TECHNICAL BULLETIN

No: LA-415-002
Issue: 1
Date: 08 Sep 2005

KIT Accessory DVD Poor Sound Quality

Land Rover LR3 (LA)

Figure 10

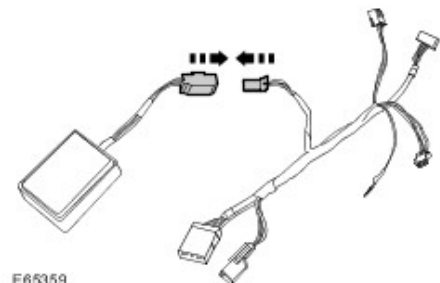
Cause: An electronic design fault within the DVD interface module is the cause of the above complaint.

Action: Should a customer express concern regarding the above, refer to the Repair Procedure detailed in this bulletin and replace the module.

8. Release the white electrical connector from the mounting bracket. (Figure 7)
9. Release the wiring harness to gain access. (Figure 8)
10. Disconnect the DVD interface module and discard the module. (Figure 9)
11. Install the new DVD interface module (VUB503990). (Figure 10)
12. Secure the wiring harness.
13. Secure the white electrical connector to the mounting bracket.
14. Secure the DVD interface module to the mounting bracket.
15. Where installed, connect the rear A/C control electrical connectors.
16. Connect the electrical connectors.
17. Connect the ground connection and position the DVD unit.
